# Brookline Preservation Commission

## Local Historic District Report

Address: 12 Worthington Road

Applicant: ZeroEnergy Design

Visibility of existing low wall connecting house and garage (top); Visibility of garage from Worthington Road (bottom)

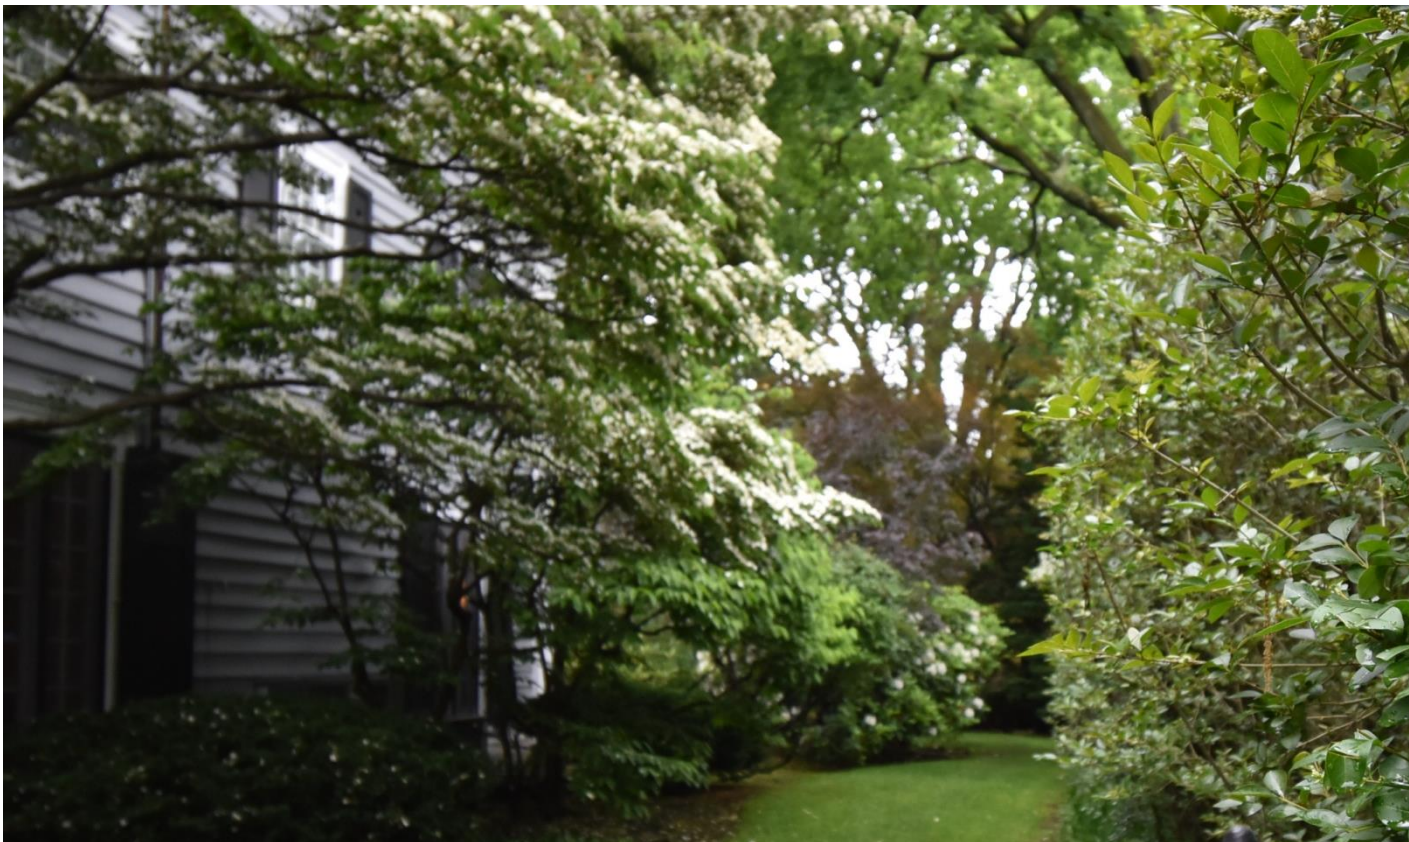
The proposed construction of the addition to connect the garage to the house is not supported by the Design Guidelines. In the section on new construction, the Guidelines state that garages should not be connected to the house if the prevailing historic condition in the neighborhood is detached garages. This historic garage is detached, as is the one next door and many others on the street. The Commission has a strong track record of upholding the requirement that detached garages remain detached. If attached garages are allowed, the Guidelines specify that they should not face the street, which this one does. Further, the demolition of the existing library removes a portion of the house that is preferably preserved even though it is not original. The design review principles established in the Design Guidelines state that changes to a property that have acquired historic significance in their own right should be retained and preserved.
